**RECORD DRAWING  
DECEMBER 27, 2013**

**VERMONT AGENCY OF TRANSPORTATION**

PROJECT NAME: RUTLAND SOUTHERN VERMONT REGIONAL AIRPORT  
CLARENDON, VERMONT  
PROJECT NUMBER: AV14-8008-300  
FILE NAME: z07h124ar\_repave-rd.dgn  
PROJECT LEADER: F. WALSH  
DESIGNED BY: G. D'AMICO  
AIRPORT ROAD REPAVING PLAN  
PLOT DATE: 12/30/2013  
DRAWN BY: R. ROSS  
CHECKED BY:  
SHEET 7 OF 29

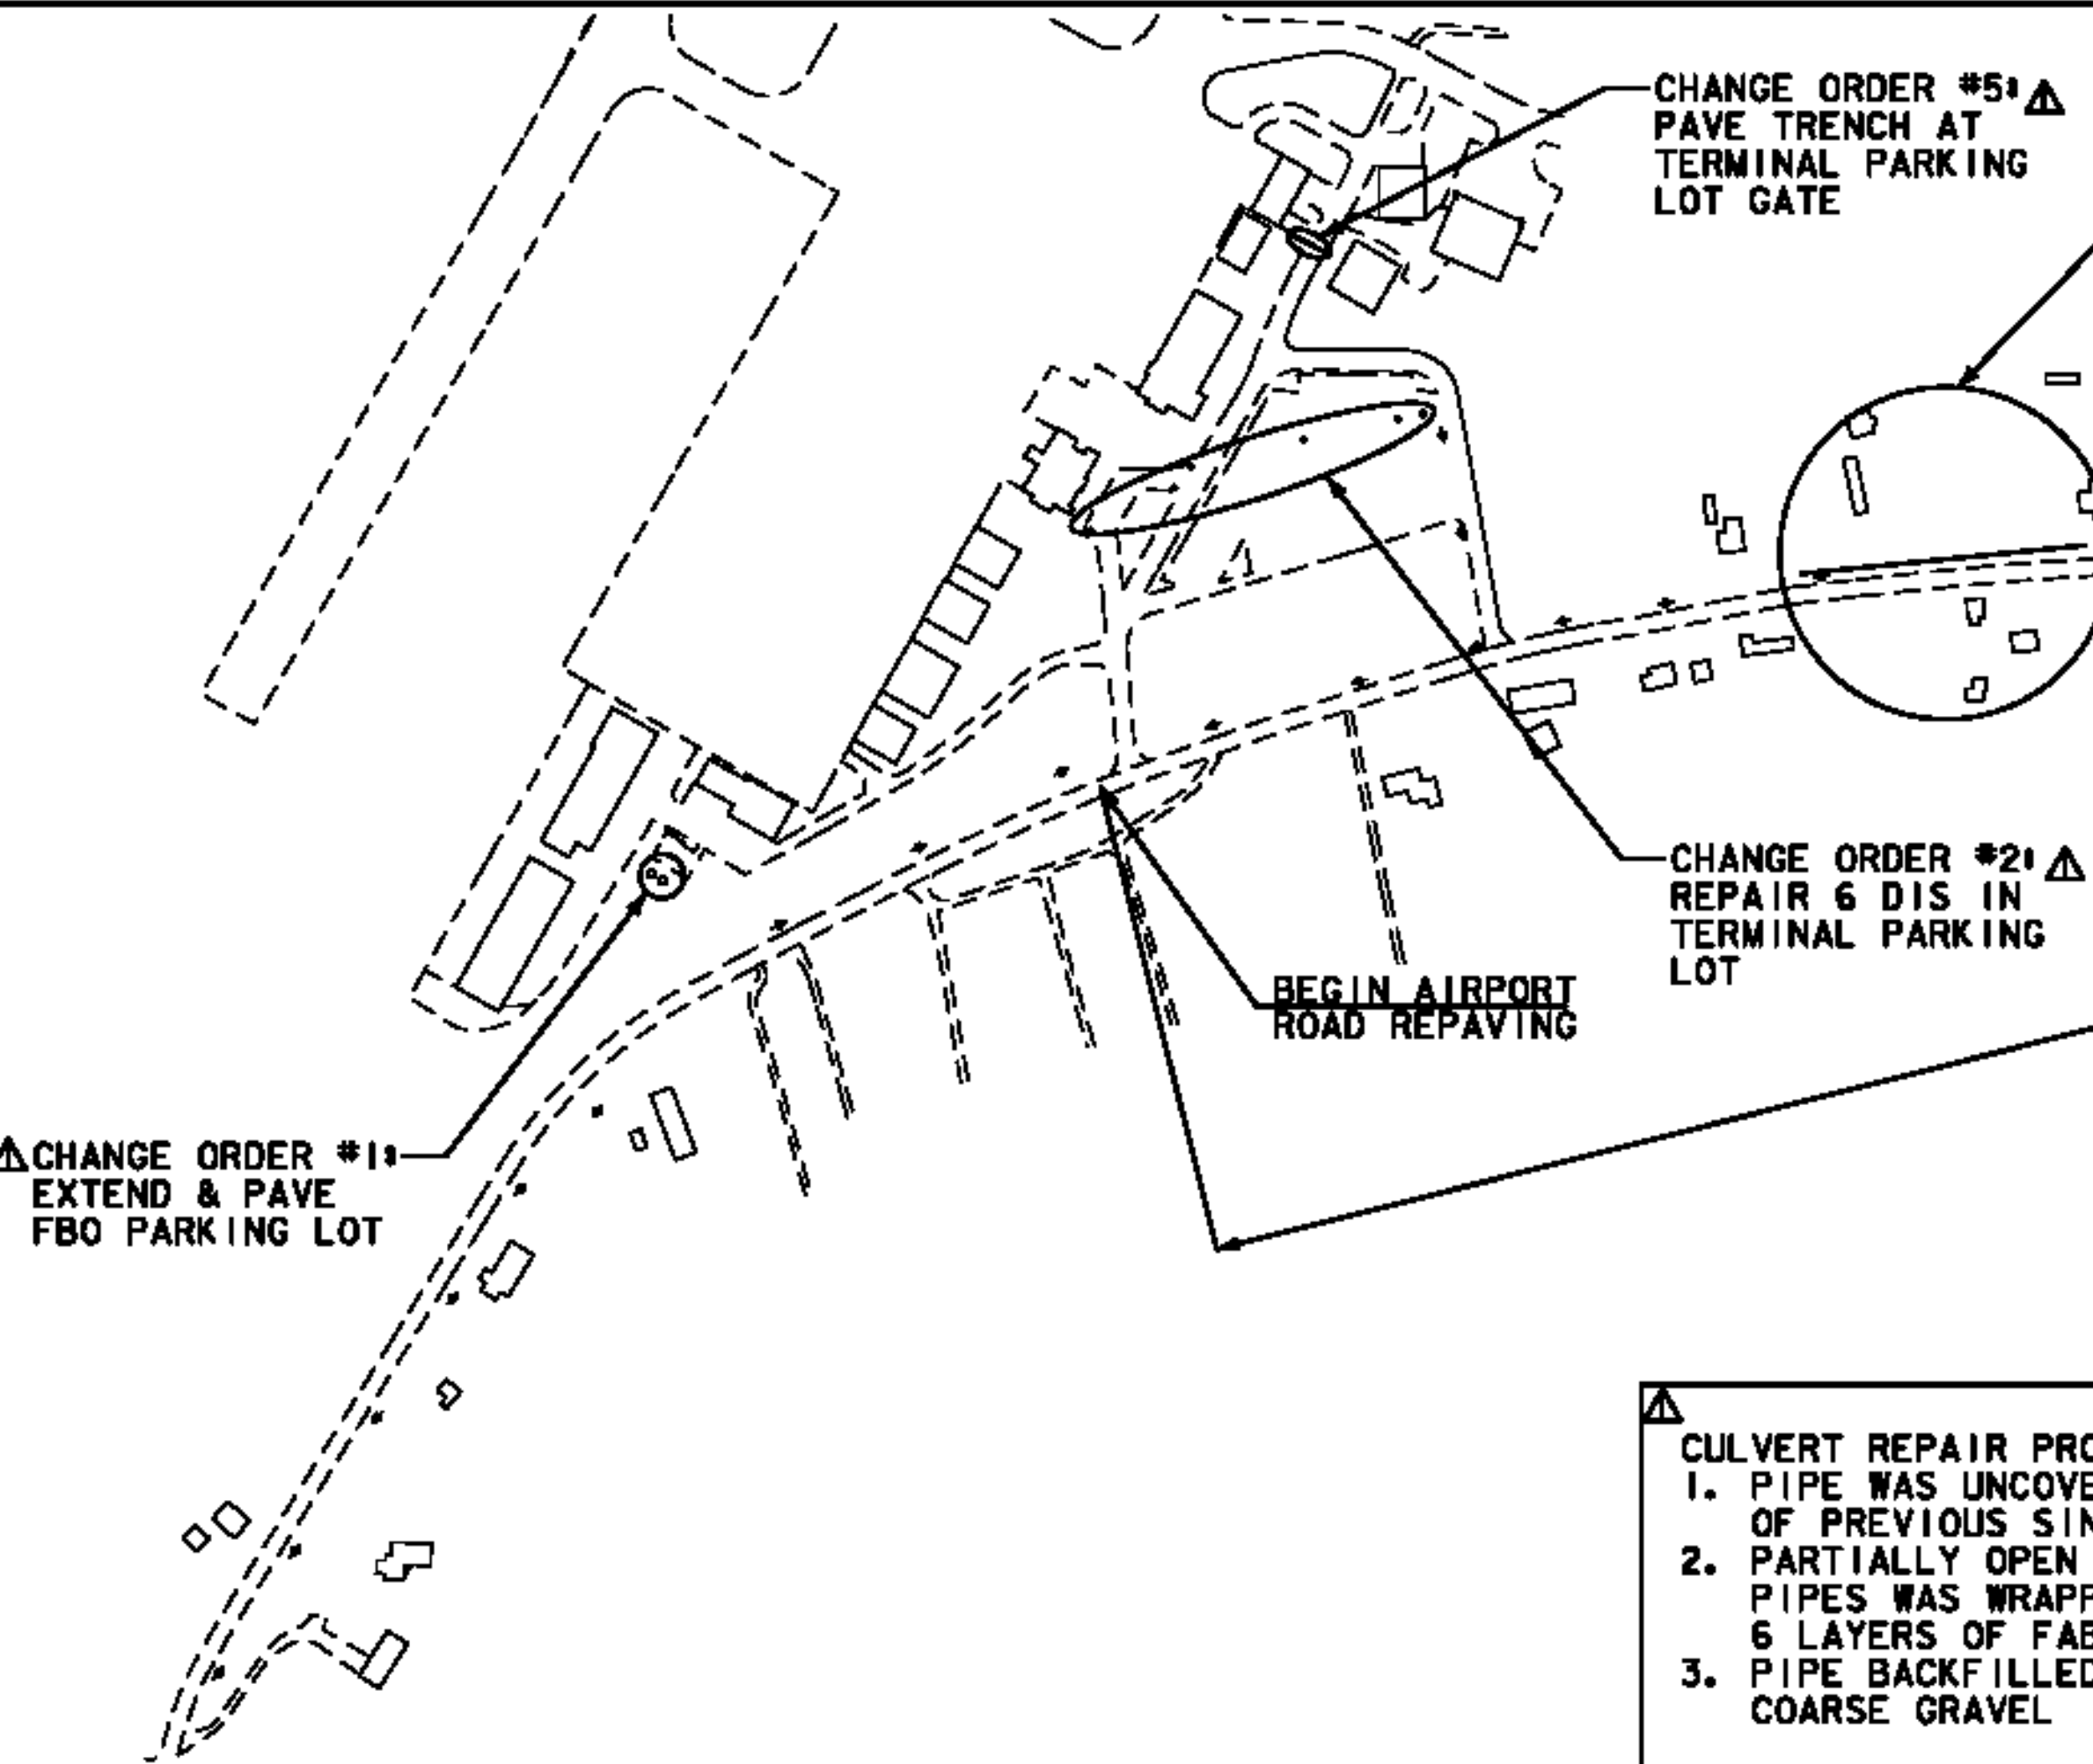
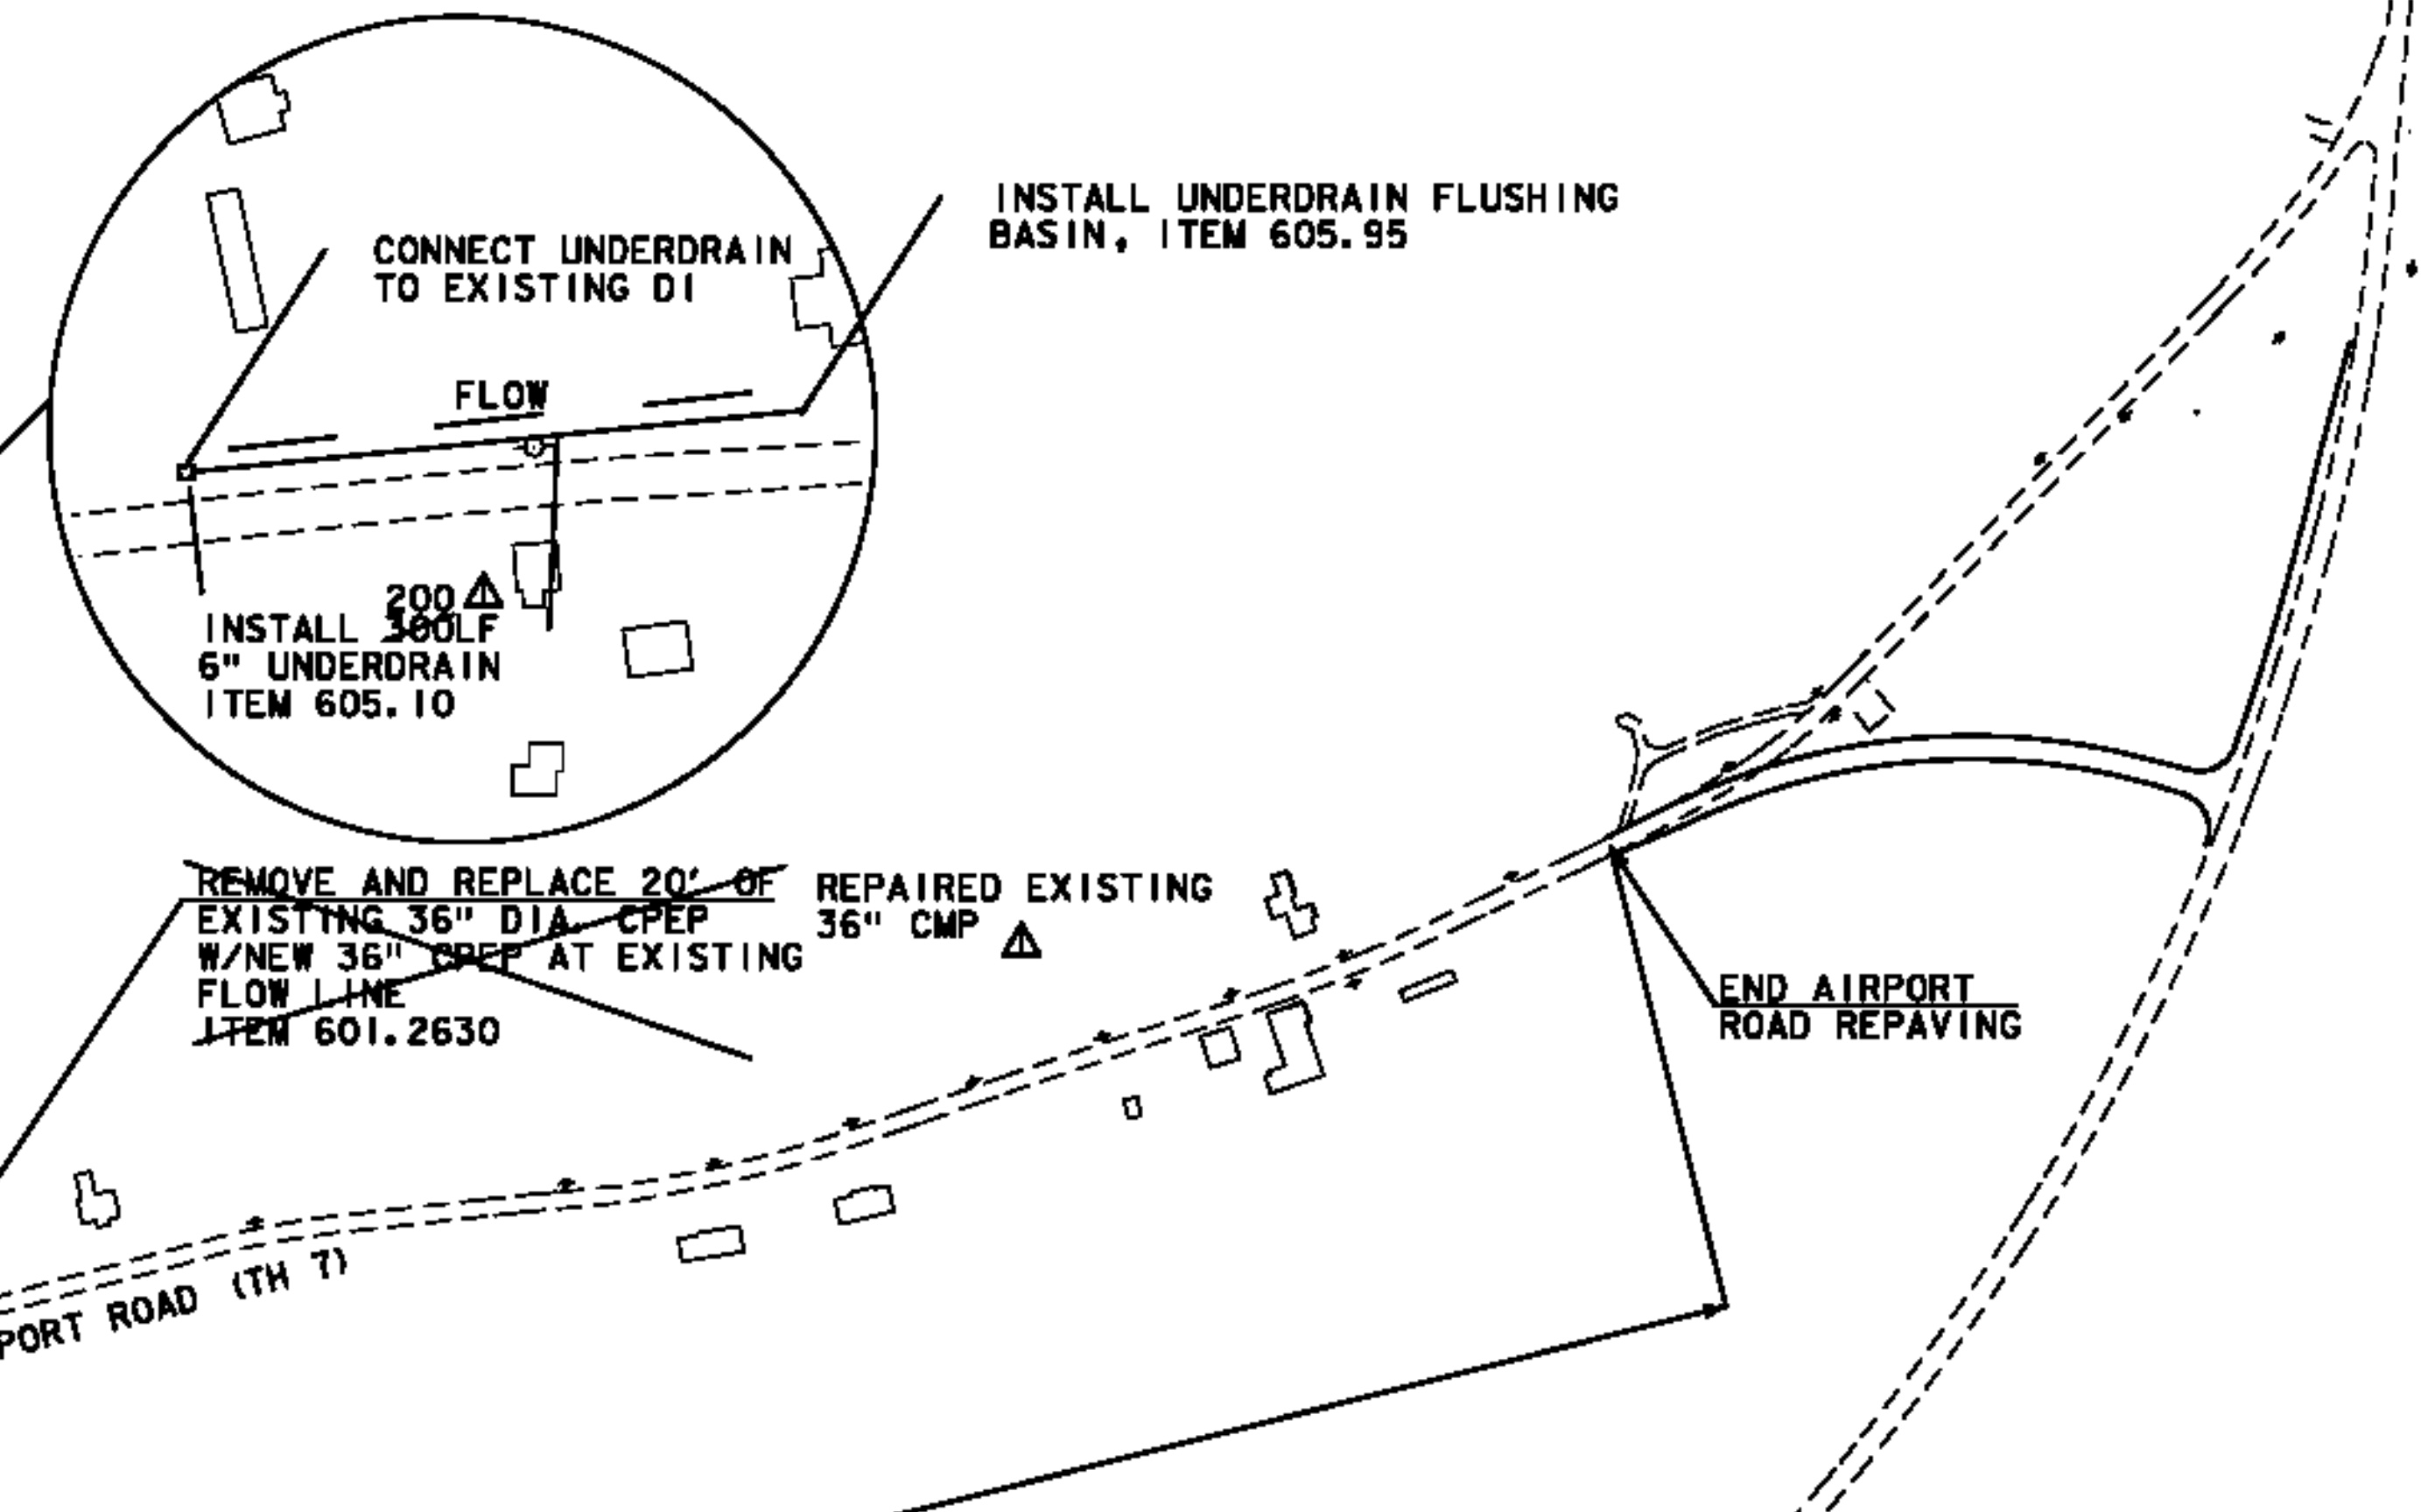
- CULVERT REPAIR PROCEDURE:**
1. PIPE WAS UNCOVERED AT SITE OF PREVIOUS SINKHOLE
  2. PARTIALLY OPEN JOINT IN PIPES WAS WRAPPED WITH 6 LAYERS OF FABRIC
  3. PIPE BACKFILLED WITH COARSE GRAVEL
